DOC NO. 150-040073

## Service Bulletin WSB-002

### MODIFICATION OF AN RT-138 GUARD RECEIVER TO IMPROVE SPURIOUS PERFORMANCE

Figure 1) Installation of C94 with Teflon® sleeving through the shield fence.

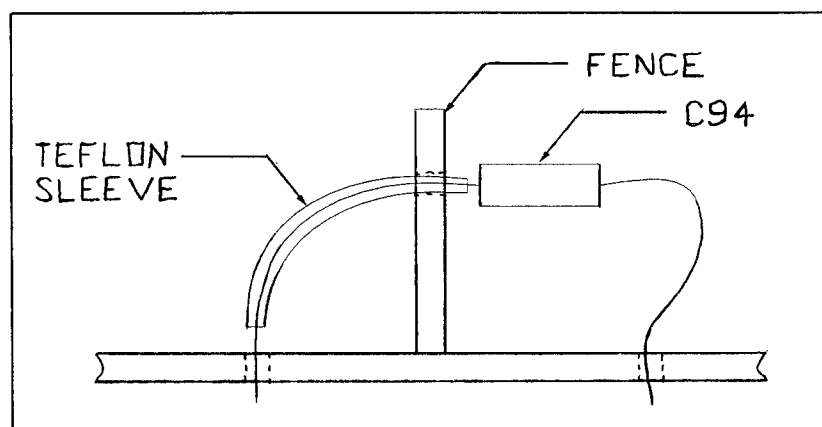
To modify the receiver, inductor L17 is changed to a capacitor (C94), and the value of capacitors C51 and C54 are changed.

- A. Remove the top cover from the transceiver.
- B. Remove the Guard Receiver Module from slot A8 per the RT-138F Maintenance Manual, Report 1325.
- C. Install capacitor, C94, PN 106-00001-0008 with Teflon® sleeving, PN 16016-22 in place of inductor L17. Refer to Figure 1 for application of sleeving.
